Service Note		
Product	Description:	Service note no.
M5000	Modification to avoid E03 (view CCW)	712-100509

This modification concerns only M5000s with serial no. between 281505 and 281775.

Fig. 1: Location of R4 and R6.

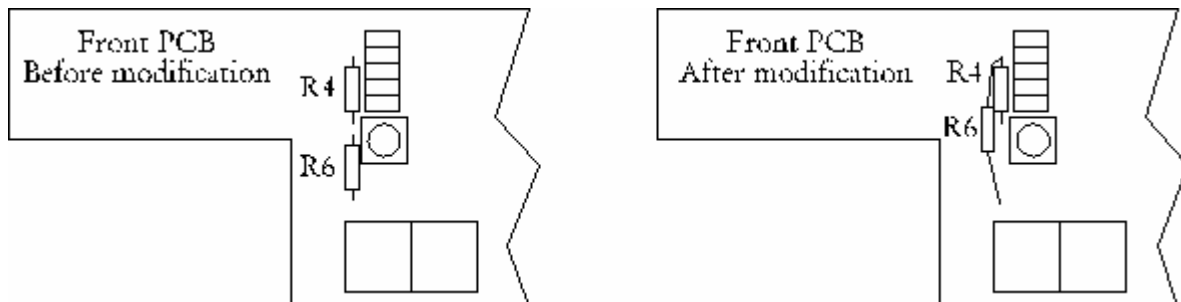
If the viewing angle knob is turned completely counter clockwise (CCW) the M5000 might show E03 at power on.

To avoid this problem the following modification at the front PCB is necessary.

1. TURN OFF POWER AND DISCONNECT POWER CORD
2. Remove the front plate by unscrewing 5 screws. Two in each side and one little in the middle. Make a drawing of the position of the wires to the power switch. Disconnect the wires to the power switch.
3. Unscrew the front PCB by unscrewing the 11 screws called MT1 - MT11. Notice: MT6 is a spacer. Dismount the flat cable.
4. At the front PCB replace the resistor called R4 with a 680 ohm resistor.
5. Remove the resistor called R6. Take a new 680 ohm resistor and solder one pin to the top of R4. Solder the other pin into the lower hole of R6. See fig. 1
